In the Planning and Environment Court
Held at: Brisbane

AFFIDAVIT

Preliminary Observations About Other Change Application OTH/2025/12 – 776 Pacific Parade, Currumbin

APPLICATION FOR 'OTHER CHANGE' FOR A MULTIPLE DWELLING AT 776 PACIFIC PARADE, CURRUMBIN – LOT 1 SP348547 - OTH/2025/79

Figure 2 - Looking towards the site from Elephant Rock lookout.

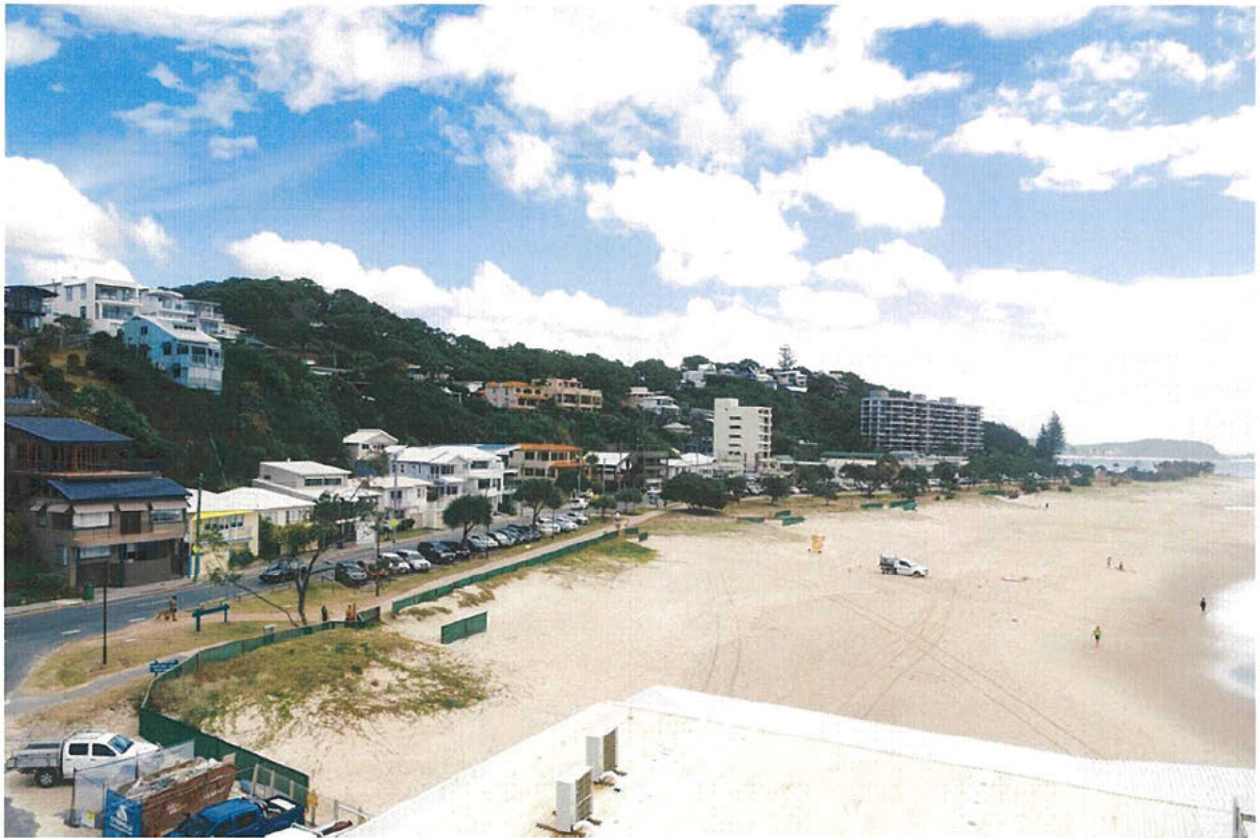
For a project of this nature, and considering the need to address the above benchmarks, I would expect that, as well as more certainty about existing and proposed landscaping, photomontage should be provided for a range of viewpoints. While visualisations and photomontages have been provided (setting aside the lack of information about how they have been prepared) they have only been provided for nearby viewpoints. It appears that, in order to properly understand the impact of the proposed development on the landscape features identified above, it would be necessary to see photomontage from more distant viewpoints such as the Elephant Rock lookout (refer Figure 2 below), the beach (refer Figure 3 below), and even from over the ocean.

PLAN OVERLAY

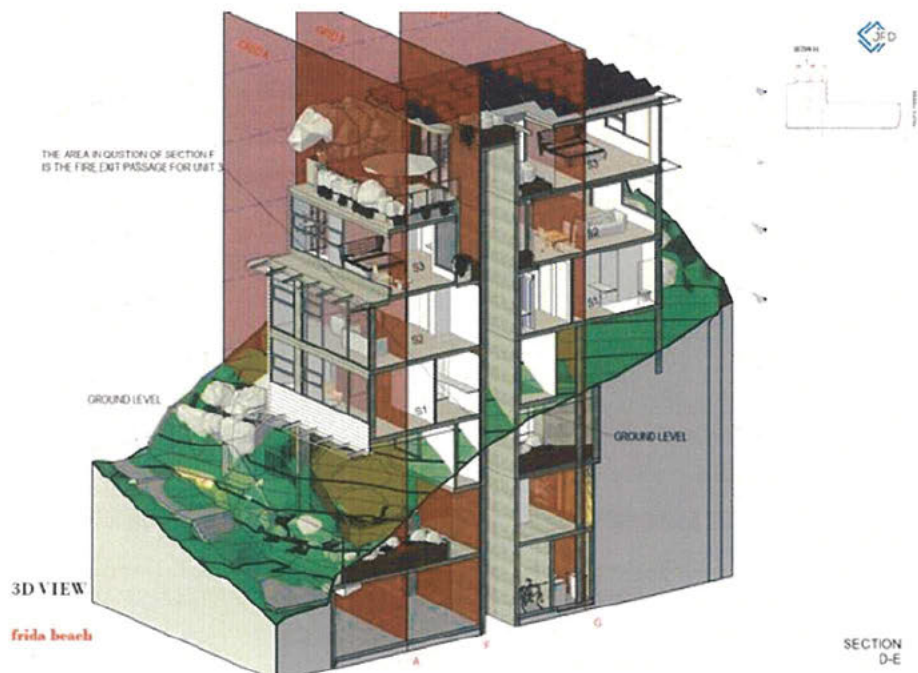
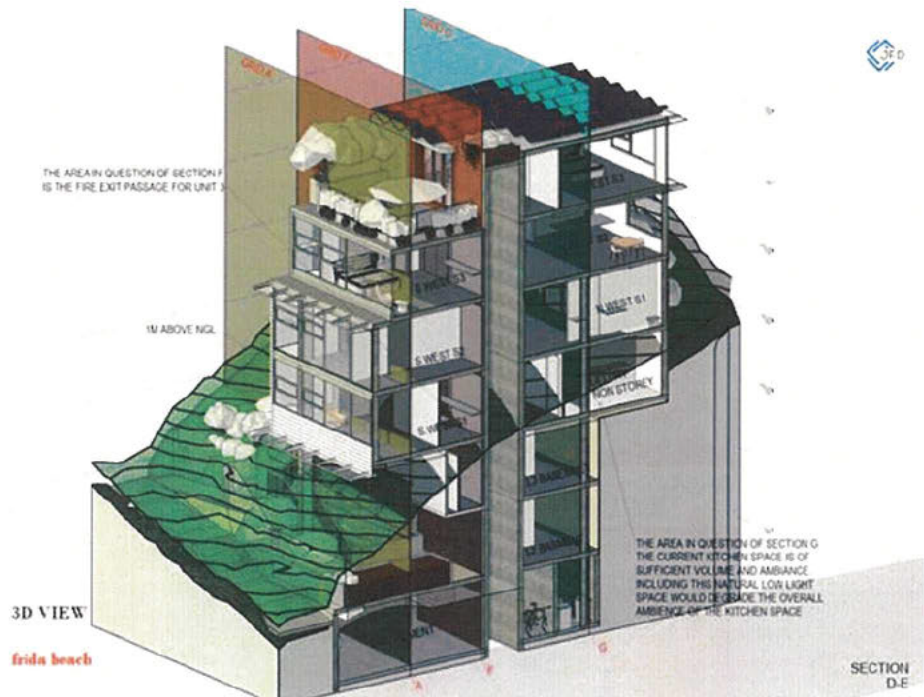
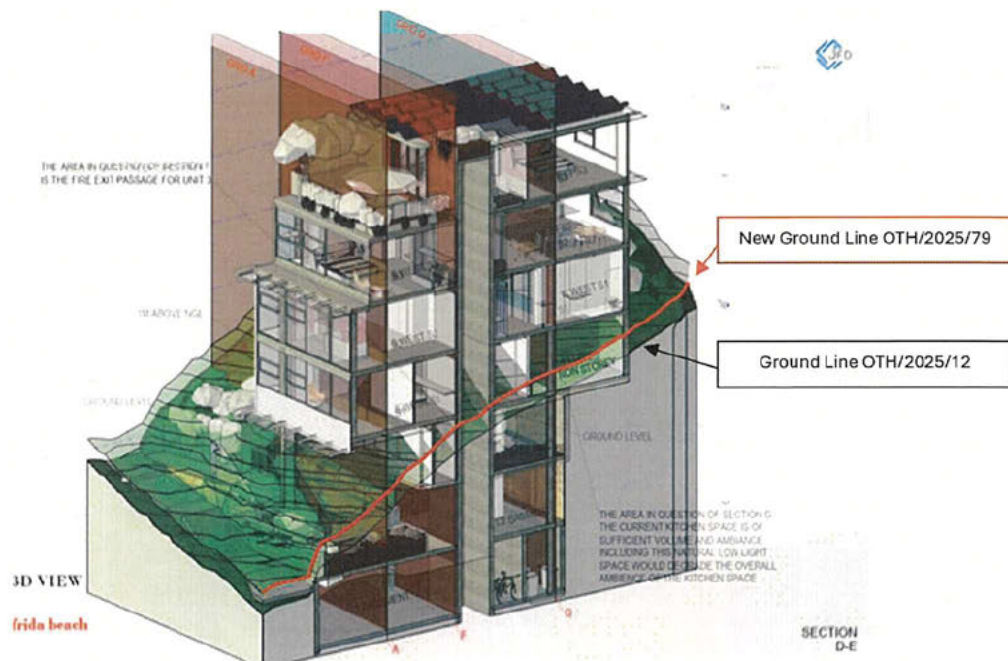
Incidentally, there appears to again be some change to ground levels shown on the sections and elevations in the plans submitted for OTH/2025/79. It is unclear what is the correct level as the plotted levels seem to have changed through various revisions submitted for OTH/2025/12 without changes to the design floor heights, and are inconsistent across plans for OTH/2025/79.

For example, *Section D-E* clearly shows the ground line raised compared to the previous plans—evident from where the line now intersects the floors on the new plan. Before Council makes any determination, the applicant ought to be required to accurately determine and depict ground levels.
